**From:** "Chopra, U.B." <UB.Chopra@transnuclear.com>  
**To:** Joseph Sebrosky <JMS3@nrc.gov>  
**Date:** Mon, Oct 17, 2005 10:03 PM  
**Subject:** RE: Submittal of revision 4 SAR pages for NUHOMS HD storage system (7 2-1030)

### List of Revision 4 SAR Changed Pages vs. Reasons for Change

Figure 2-1  
Heat Load Zones

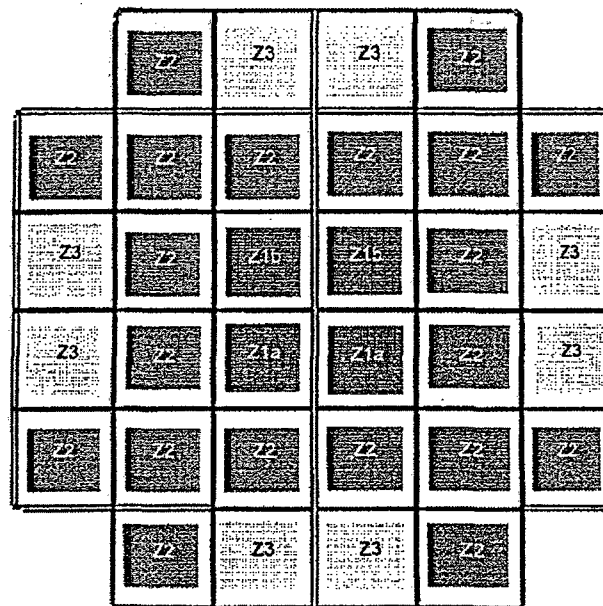
Table 2-3	Make SAR consistent with the proposed Technical Specifications
Figure 2-1	Make SAR consistent with the proposed Technical Specifications
3-ii	Make SAR consistent with the proposed Technical Specifications
3-iii	Response to RAI#2
3-iv	Response to RAI#2
3-7	Text Overflow to next page
3-8	Replace "Exceptions" with "Alternatives" to be consistent with TS and Remove Vyal-b to be consistent with revision 2 shielding analysis
3-10	(Add the term "Assembly average" enrichment). Make SAR consistent with the proposed Technical Specifications
3-13	Make SAR Chapter 3 consistent with shielding analysis (Chapter 5)
3-27	Editorial correction
3-29	Response to RAI#2
3-36	Replace air with nitrogen as a blow down medium
3-54	Response to RAI#2
3-56	Response to RAI#2
3-58	Replace "Exceptions" with "Alternatives" to be consistent with the proposed Technical Specifications
3-59	Replace "Exceptions" with "Alternatives" to be consistent with the proposed Technical Specifications

*Remove superscript -*

- $Q_{ai}$  is the max decay heat per assembly in zone  $i$
- Total Decay Heat  $\leq 34.8$  kW
- 4 fuel assemblies in zone 1 with
  - total decay heat  $\leq 3.2$  kW
  - $Q_{z1a} \leq 1.05$  kW in the lower compartments
  - $Q_{z1b} \leq 0.8$  kW in the upper compartments
- 20 fuel assemblies in zone 2 with  $Q_{z2} \leq 1.1$  kW
- 8 fuel assemblies in zone 3 with  $Q_{z3} \leq 1.5$  kW

- $Q_{zi}$  is the max decay heat per assembly in zone  $i$
- Total Decay Heat  $\leq 33.8$  kW
- 4 fuel assemblies in zone 1 with  $Q_{z1} \leq 0.775$  kW
- 20 assemblies in zone 2 with  $Q_{z2} \leq 1.068$  kW
- 8 fuel assemblies in zone 3 with  $Q_{z3} \leq 1.5$  kW
